# AMENDMENT SUBMISSIONS REPORT

State Significant Development No. 5765

March 2022

# **Bowdens Silver Project Amendment Submissions Report**

Figure 3.1  
**EXISTING AND PROPOSED ALIGNMENT OF THE 500KV POWER TRANSMISSION LINE**

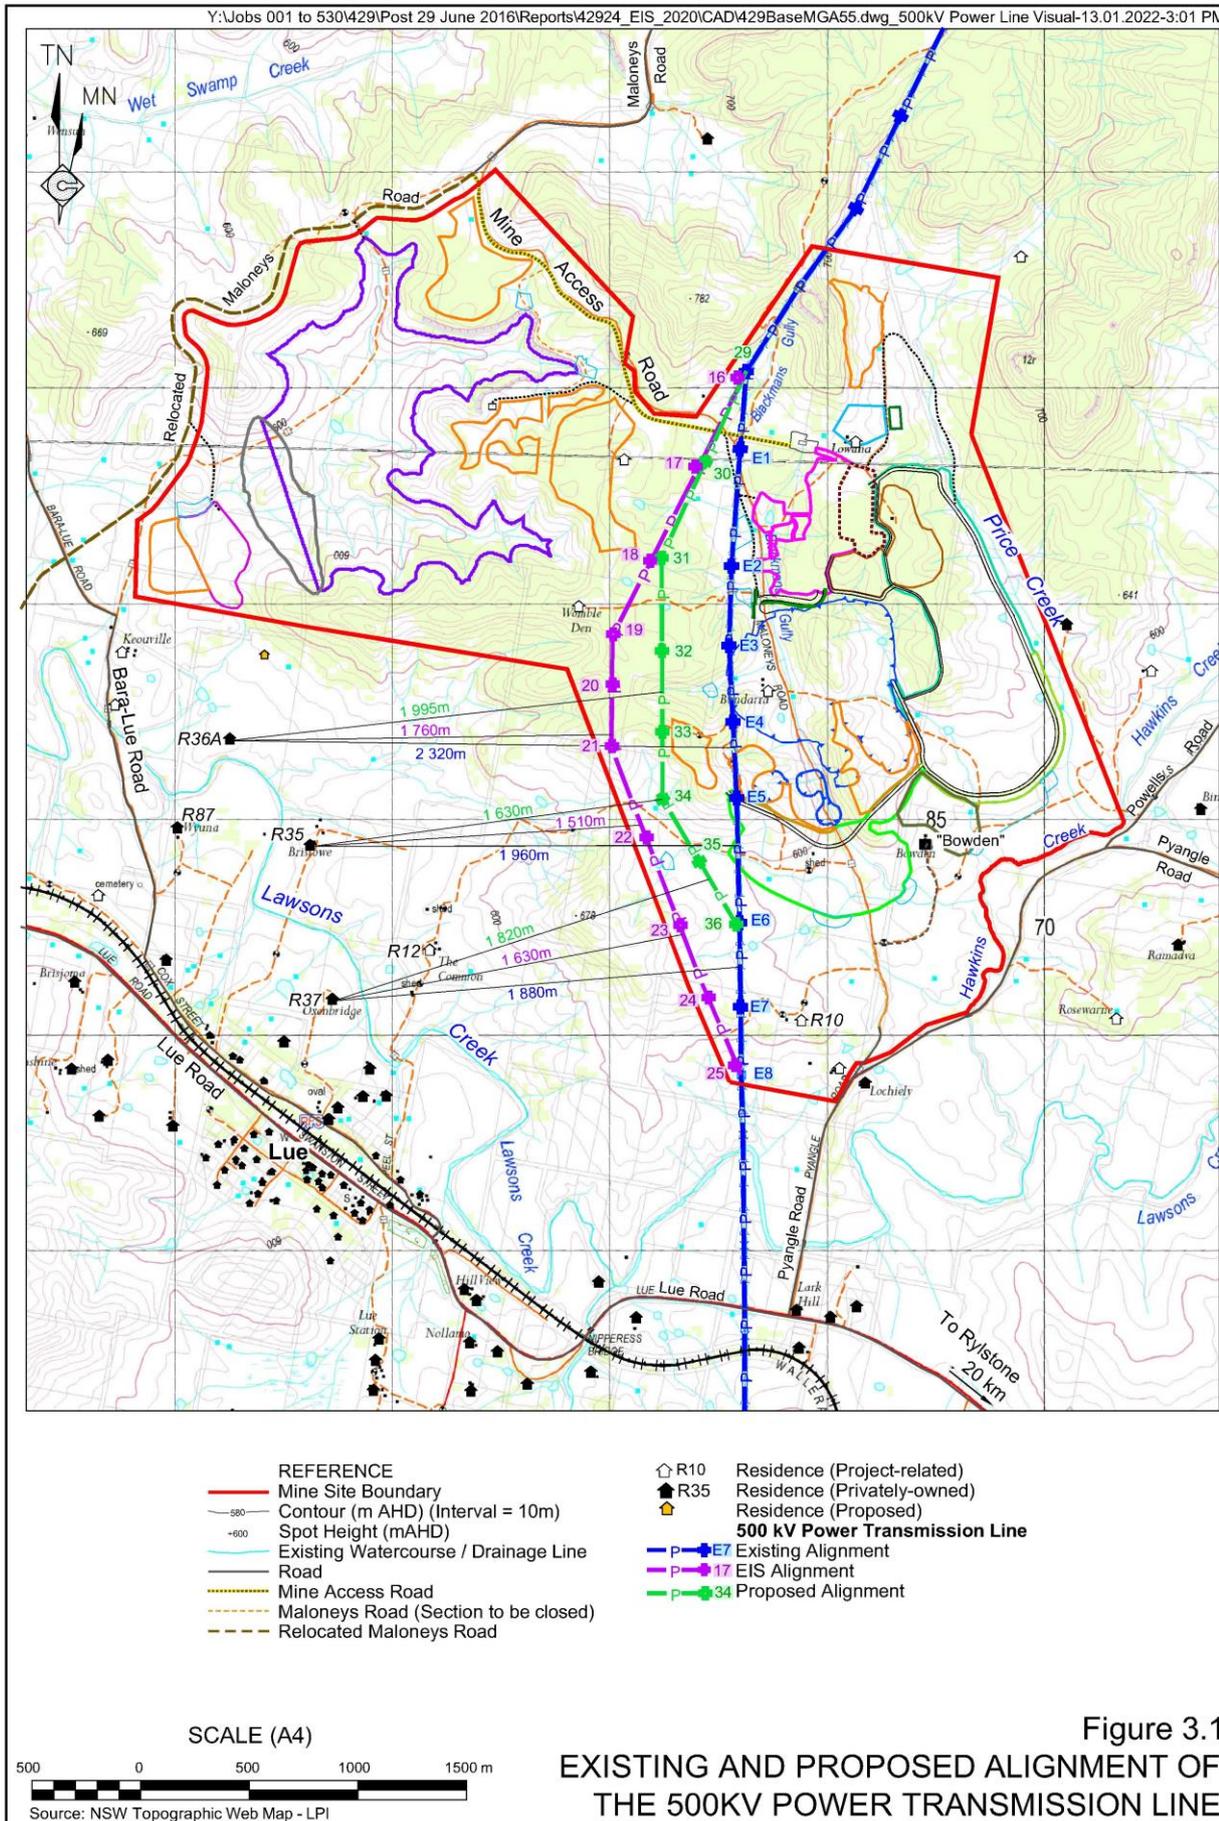
As identified in **Figure 3.1** and described in detail in GHD (2022), the new proposed alignment of the 500kV power transmission line results in the lines being moved approximately 300m to the west of mining infrastructure, not 500m as originally proposed.

An alignment located at least 300m from the open cut pit was selected as this location was considered to provide a safe offset distance from mining activities while also improving visual amenity outcomes for landowners to the west and southwest of the Mine Site. The alignment also considers the risk of sterilising potential resource in the vicinity of the open cut. The alignment presented in the EIS and *Amendment Report* was compared to the selected alignment in relation to design parameters and visibility. A summary of this review is presented in **Table 3.1** and the alignment now proposed is presented in **Figure 3.1**. The review of the 500kV power transmission line options refers to the following.

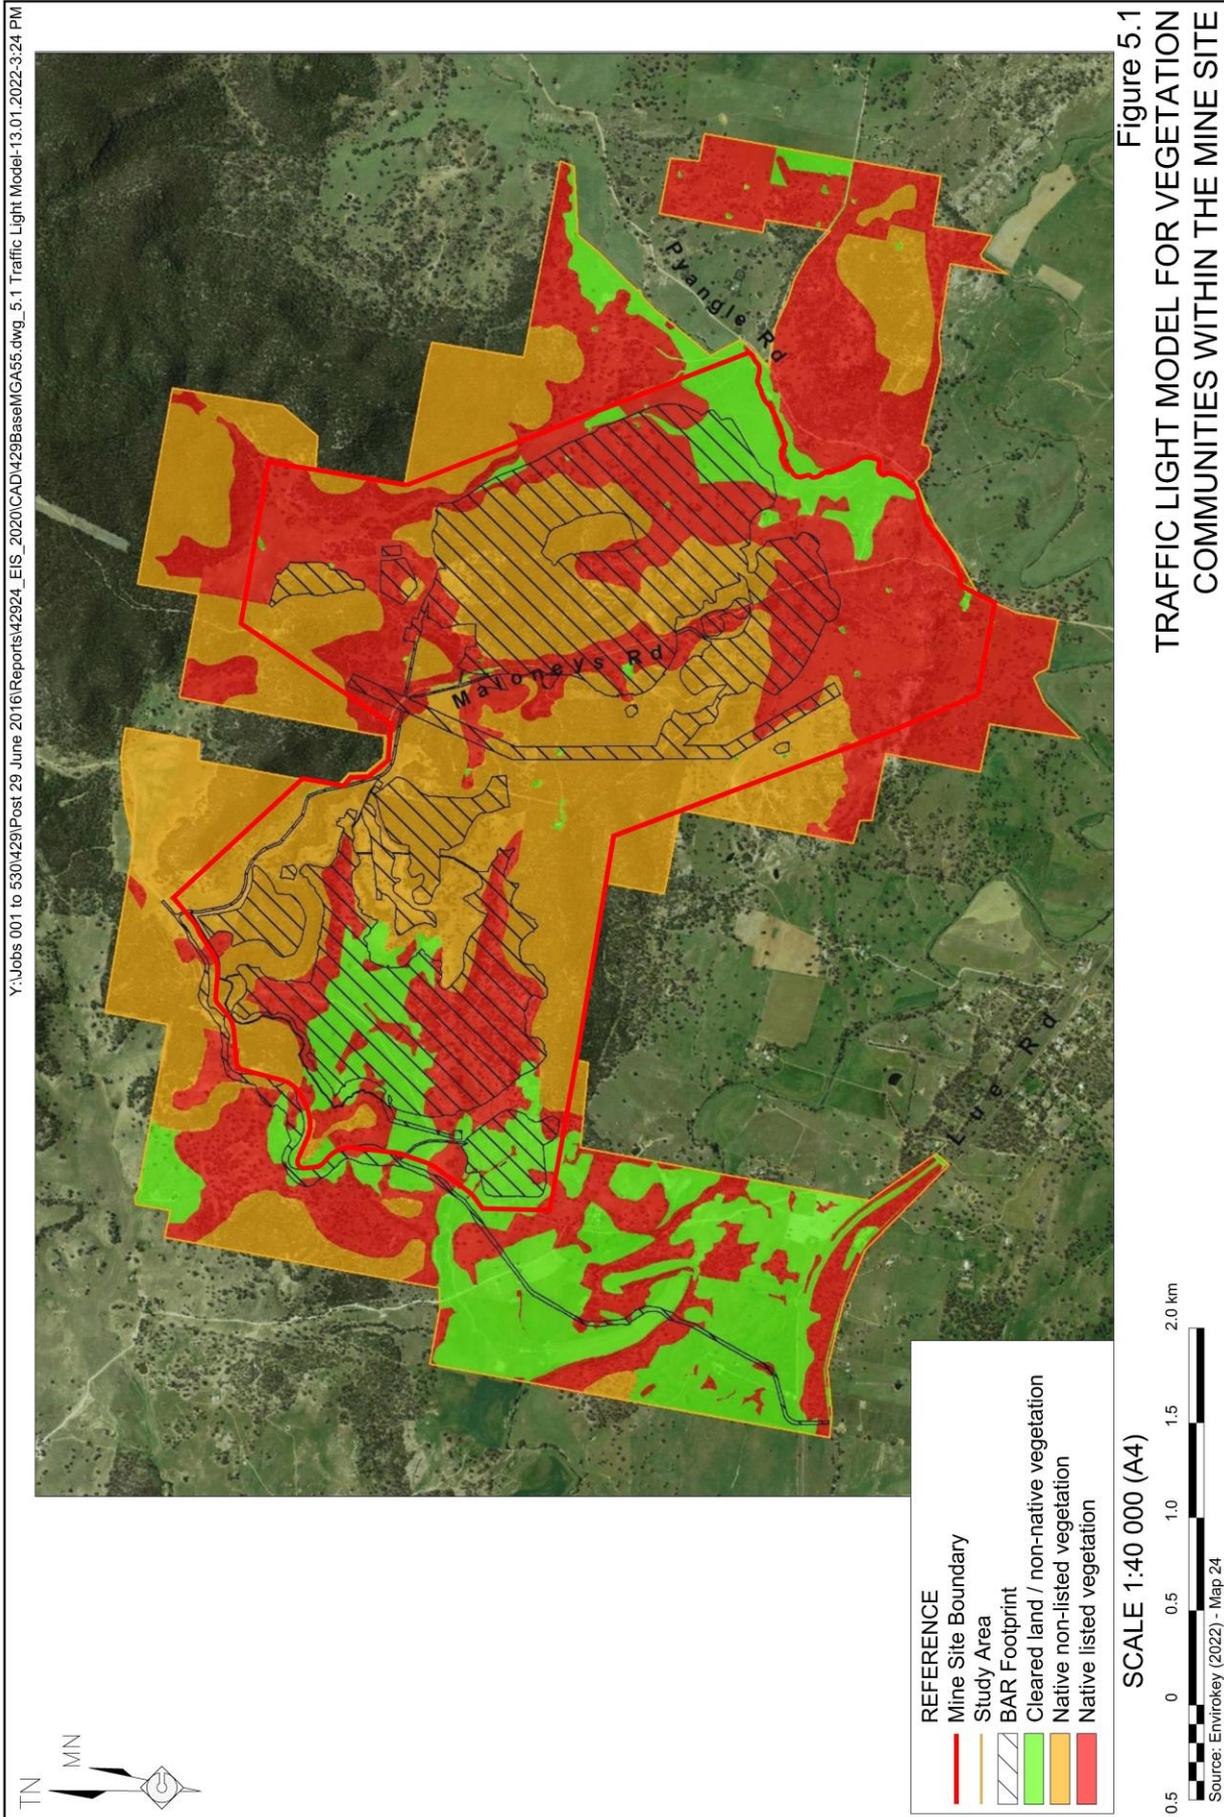
*Measures that have been taken to avoid impacts on biodiversity should be clearly explained in the BAR. Changes to mine layout or the pipeline route that have been made to avoid impacts should be described and mapped.*

The traffic light model prepared by EnviroKey is presented as Map 24 of the BAR (see Appendix 5 of the *Water Supply Amendment Report*) and is reproduced in **Figure 5.1**. As noted in Section 6.1 of the BAR, the model was intended to provide the following guidance to Mine Site planning and design.

The traffic light model has continued to be used as the Project has been refined to guide any proposed changes to the Mine Site including the recent refinement that added water storage dams and relocated Mine Site infrastructure. Similar to the approach taken for the original Mine design it was the traffic light model that informed where dams and other infrastructure should not be located.

Recent review of the Mine Site layout in response to the realignment of the 500kV power transmission line and the removal of the water supply pipeline and its replacement with on-site infrastructure was informed by the traffic-light model. However, it was also informed by a preference for a compact Mine Site at which potential indirect impacts may also be avoided. This involved placing dams or soil stockpiles in locations between other Mine Site features such as in the vicinity of the satellite open cut pits. The permitted removal of vegetation clearing in some areas and use of areas that were more likely to be subject to indirect impacts due to their proximity to other mining-related infrastructure.
